**RE: Objections to SSD-27028161**

## **Morisset Park and District Action Group (MPDAG) formal objections to SSD-27028161.**

### Objection 1. – Morisset Park area 1.

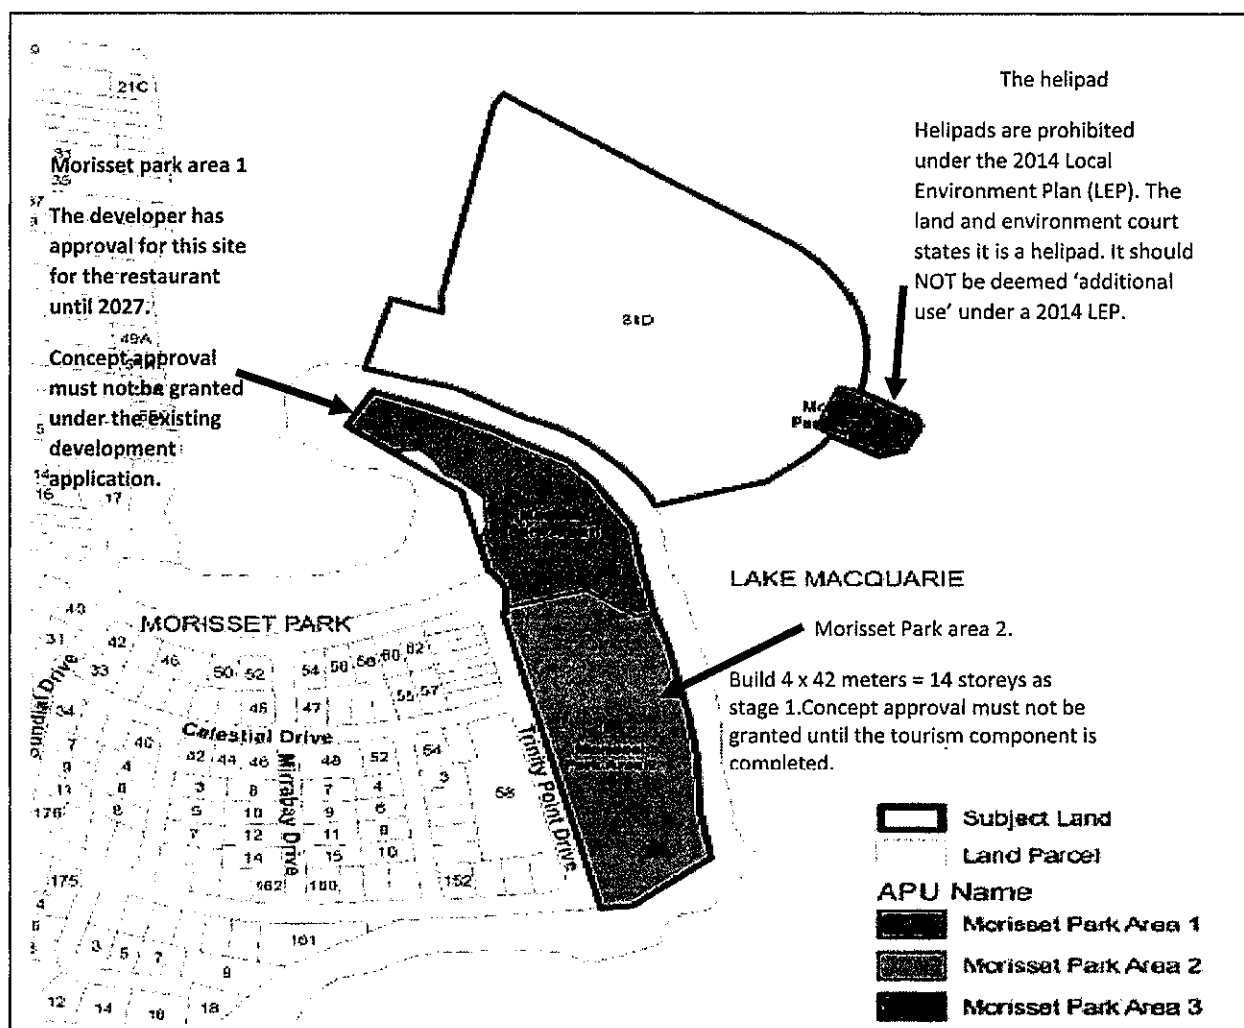
- a) 2 approvals for the same Morisset Park Area 1 where a current D.A. was approved by Lake Macquarie City Council for the next 5 years (2027).

There is no guarantee the developer will ever build a hotel on Morisset Park Area 1 as a current DA is approved until 2027.

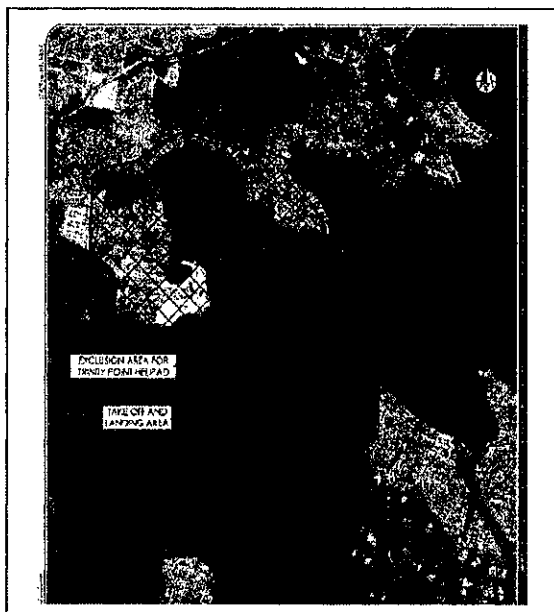
Under no circumstances should Area 3 be classified and re-purposed as **Additional Permitted Use** and described as an area for food and drink.

The helipad is what it is- **a helipad!**

It was always intended as a helipad and approved by the Land and Environment Court in December 2019 as a helipad with restrictions attached for a 'no fly zone.'

### **BUSHFIRE SAFETY ISSUES**

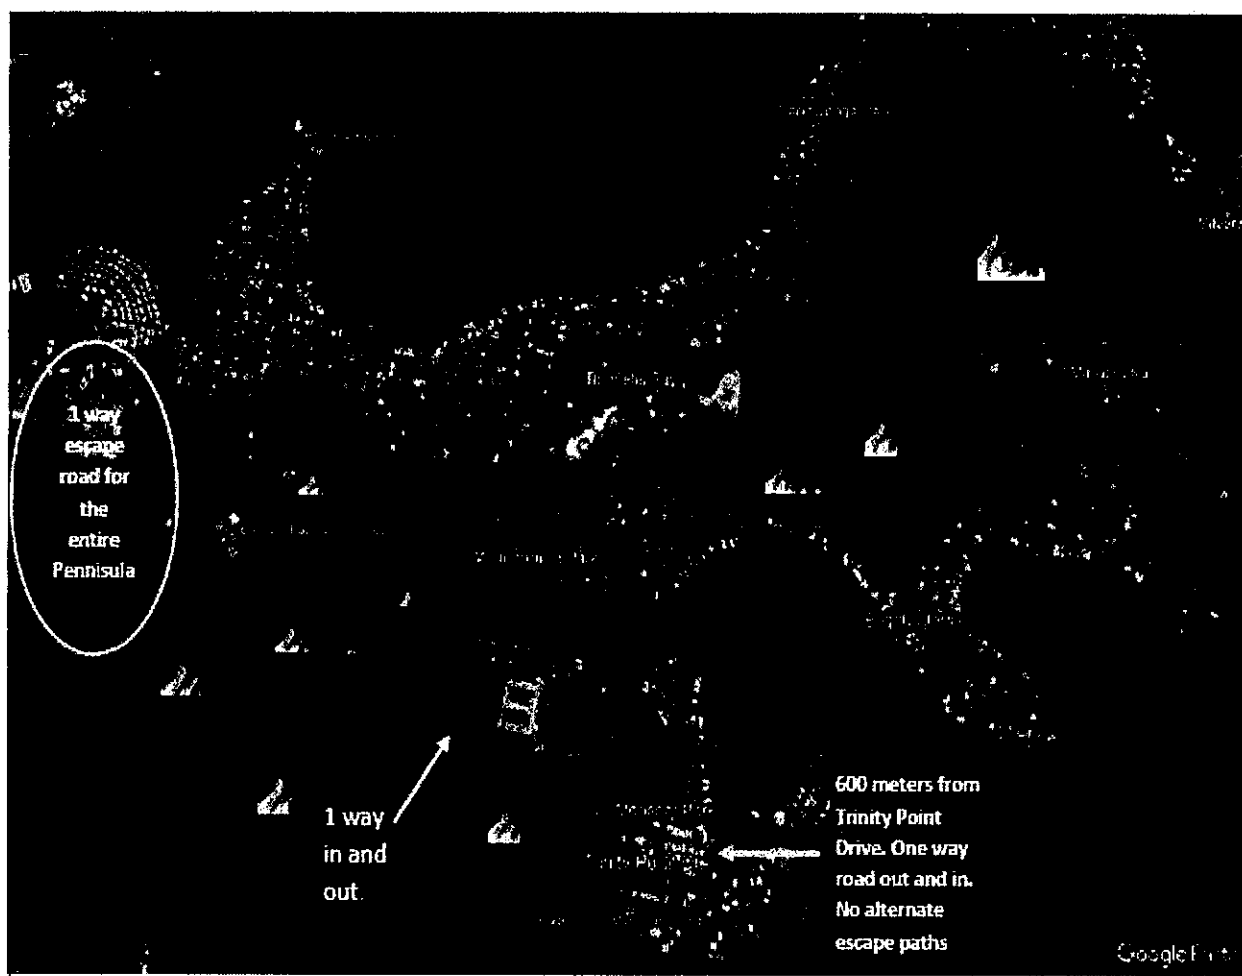
The area is a peninsula i.e. Fishery Point Road which is one road in and one road out.

The proposed Trinity Point development is 5 kilometres from Morisset via a one road in and one way out road i.e. Trinity Point Drive and Morisset Park Road. Both roads on each side are bounded by dense bushland.

**NOWHERE in this proposal has the developer identified the bushfire hazards or an escape plan for Morisset Peninsula.**
